Approval Drawings

ICF general arrangements, steel over ICF, elevations, sections and the questions for the engineer

Icf Homes - Dendrons

ISSUED	24.09.26
SHEETS	15
DRAWN BY	BuildEase

DRAWING TITLE
GF ICF GENERAL ARRANGEMENT

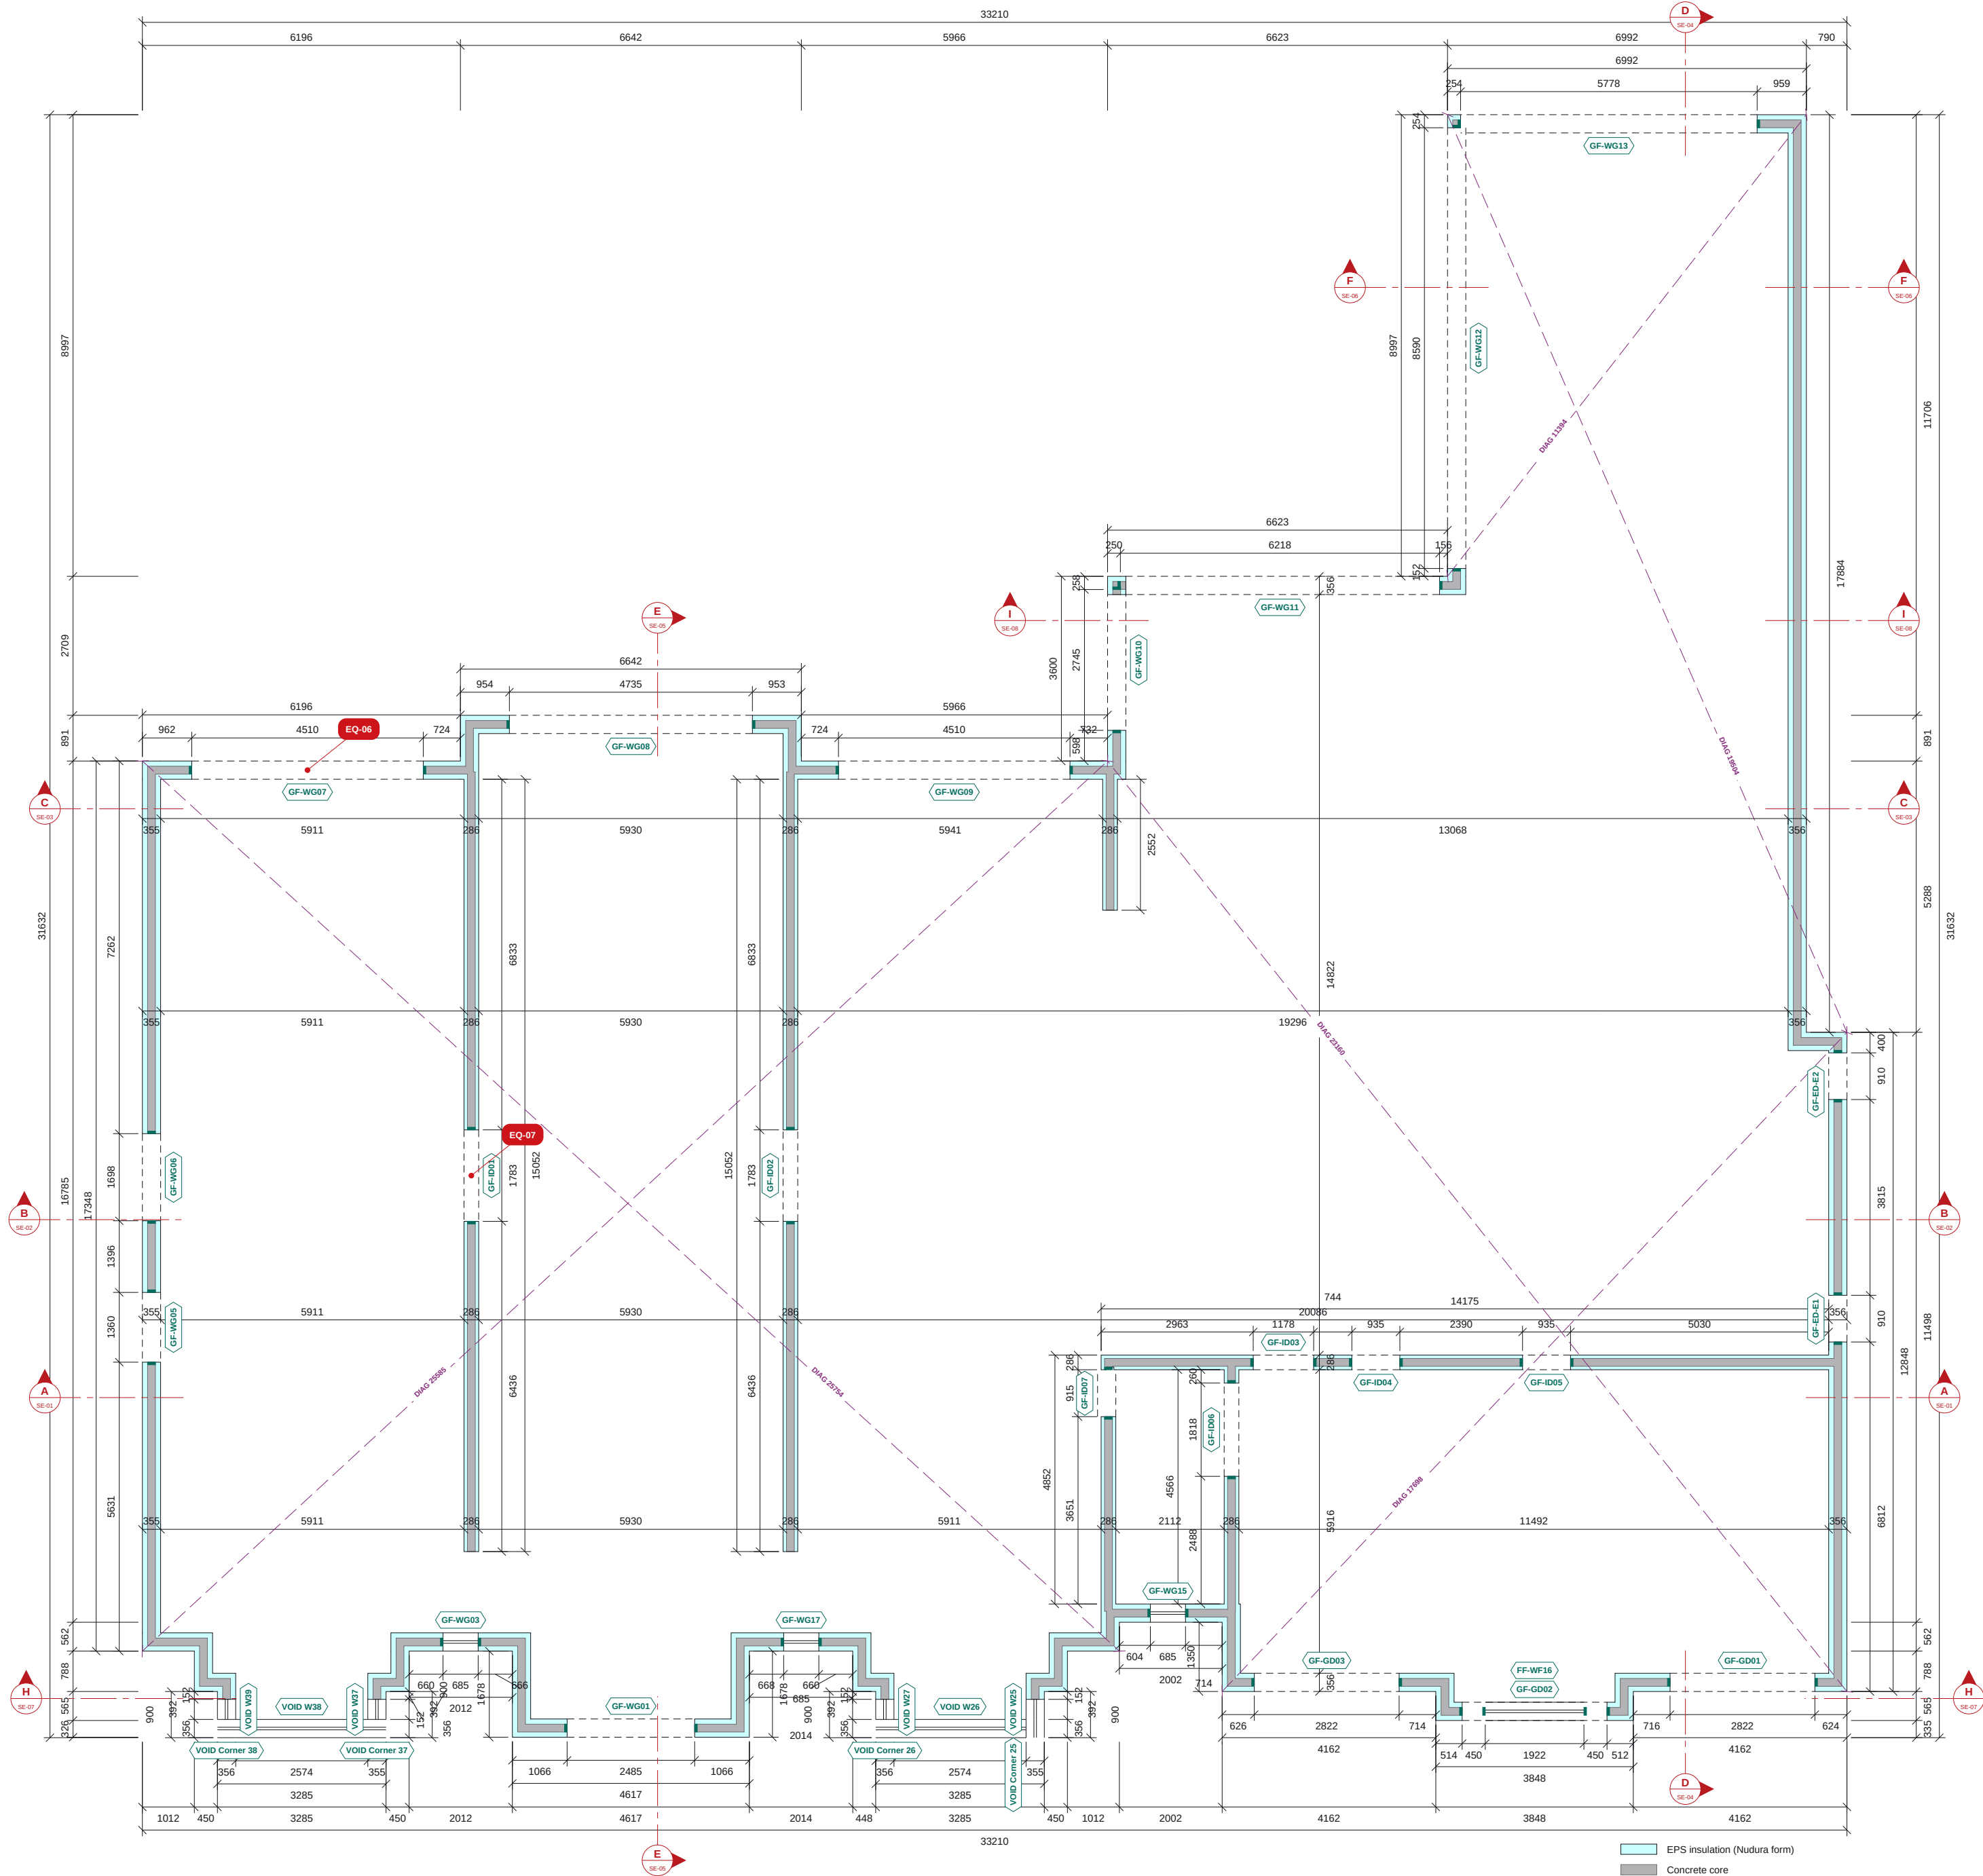
ISSUE GF north openings GF-WG07/08/09 (heads at 2948 = 171.598 AOD): the scheduled RCB152 x 375 - 2H20 reaches 3323, 23 mm above the hollowcore soffit 3300 (S-101 TOC 172.100, 150 planks). FF north windows FF-WF05/11 (heads 6023): the RCB152 x 350 - 2H20 reaches 6373, 48 mm above the FF wall top (174.975 AOD, the second-floor joist bearing). Both modelled as drawn. The pool-hall screens GF-WG10..13 carry the S-101 high-level beams FF-S16/S06/S07/S01 with no RC lintel.

QUESTION Please confirm the lintel / bearing arrangement at these openings.

FF STEEL OVER ICF

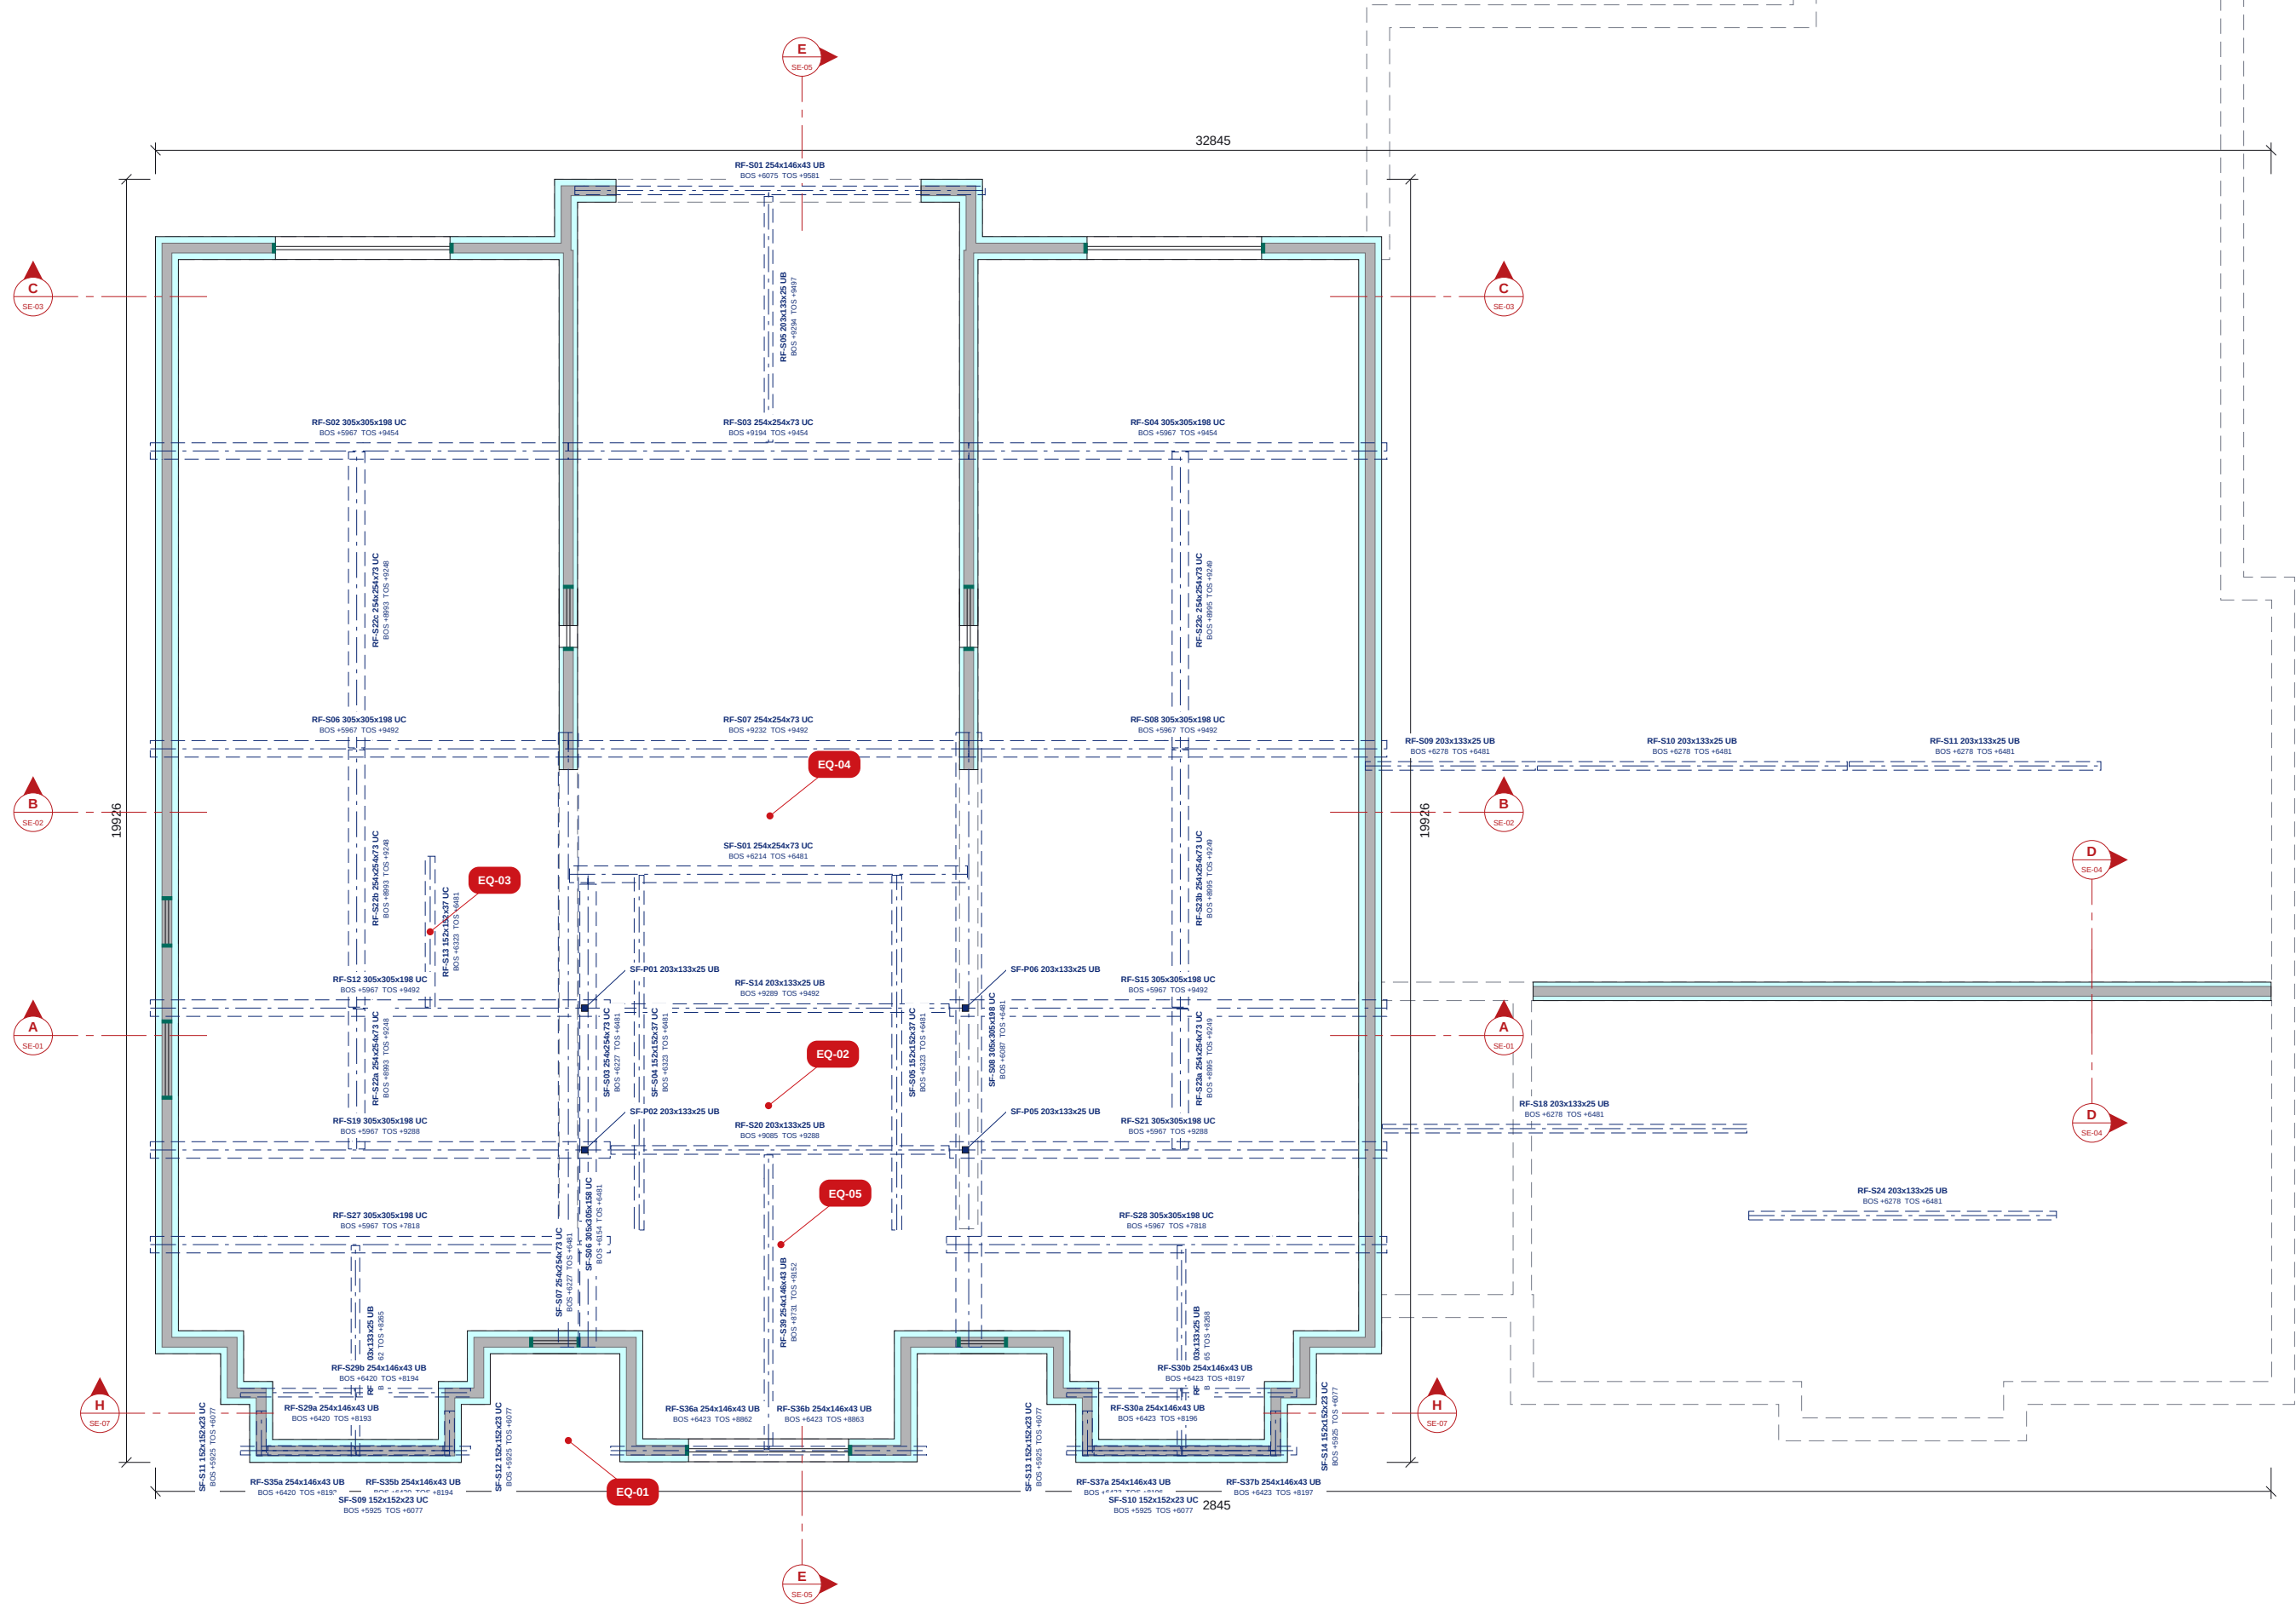
QUESTION Please confirm its purpose and bearings (lift overrun trimmer?).

EQ-01 SF-S06 / SF-S08 bearings over the FF windows FF-WF02 / FF-WF19 (S-102, S-121)

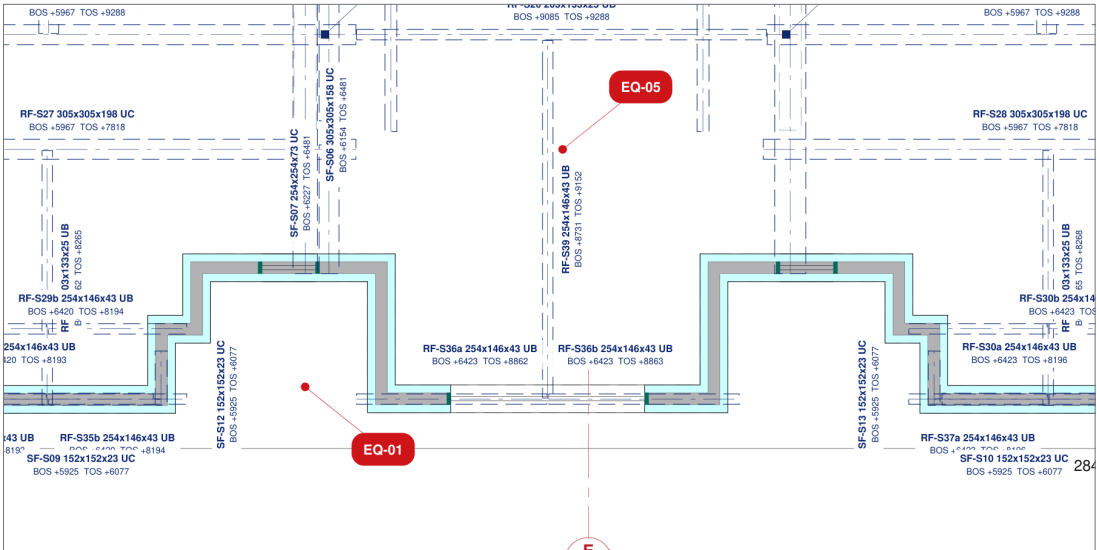
ISSUE The second-floor transfer beams SF-S06 (UC 305x305x158, x 6370) and SF-S08 (UC 356x406x287, x 12586) bear on the south wall (L2, top 174.975 AOD) directly over the 685-wide FF windows either side of the entrance bay. At TOS 175.229 the beam undersides are 6252 (S06) and 6185 (S08) above the slab datum; the architect's window head is 6023, leaving 229 mm (S06) and 162 mm (S08) of wall between head and beam. S-121 schedules an RCB152 x 300 - 2H16 lintel there, which would reach 6323, 71 mm into SF-S06 and 138 mm into SF-S08.

QUESTION Please confirm the bearing detail: a steel spreader under each beam end (model assumption UC 152x152x30, 1285 long, 300 bearing each side, TOS = beam underside), or a revised lintel / beam arrangement. The window positions are the architect's and are held.

EQ-02 Stair void on S-101 vs the architect's main stair (Plan FF, Sections A-A / E-E)

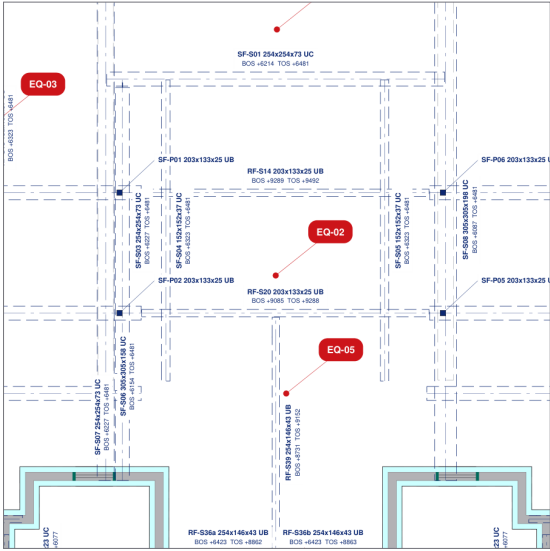
ISSUE S-101 shows the stair void as the ellipse only (x 6.5..12.4 m, y 2.2..6.2 m) with a UC 203x203x46 trimmer on its north tangent (y ~6.23 m, TOS 171.950, 'WALL BELOW') and hollowcore north of it. The architect's two curved flights (19 risers each) continue north beside a 3.3 m slot and land on the first floor at y ~8.9 m; that trimmer and the planks north of y 6.23 m would sit 1.1-1.5 m above the treads.

QUESTION Please confirm the extent of the first-floor void (model: ellipse + flights + slot to y 8.93 m, planks HC-032/033/034 omitted, landing edge on the plank at y 8.89 m) and the trimmer arrangement around it.

EQ-05 RF-S40 / RF-S41 bay ridge beams land 244 mm above RF-S27 / RF-S28

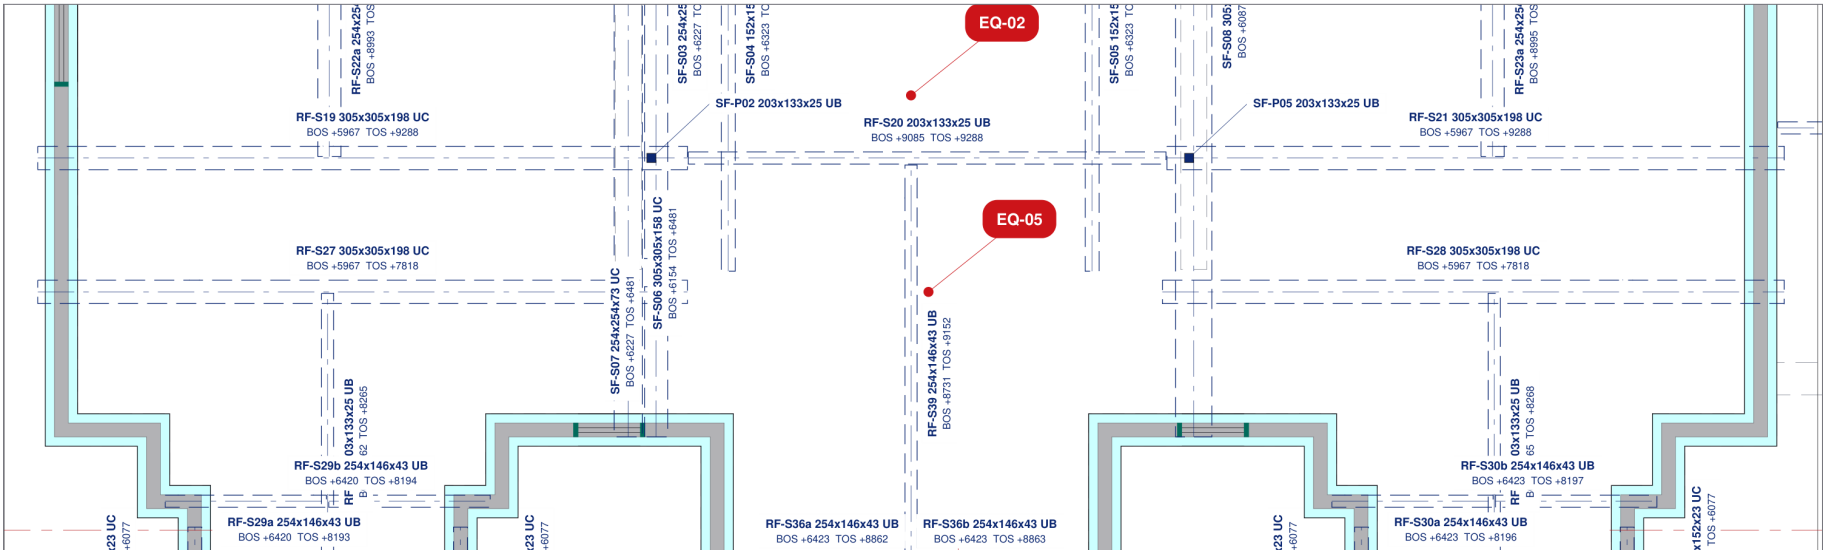
ISSUE RF-S40/RF-S41 (bay 1/3 ridge beams, TOS 177.013) land 244 mm above RF-S27/RF-S28 (TOS 176.566); modelled on 244-high stools.

QUESTION Please confirm the stool / seating detail.
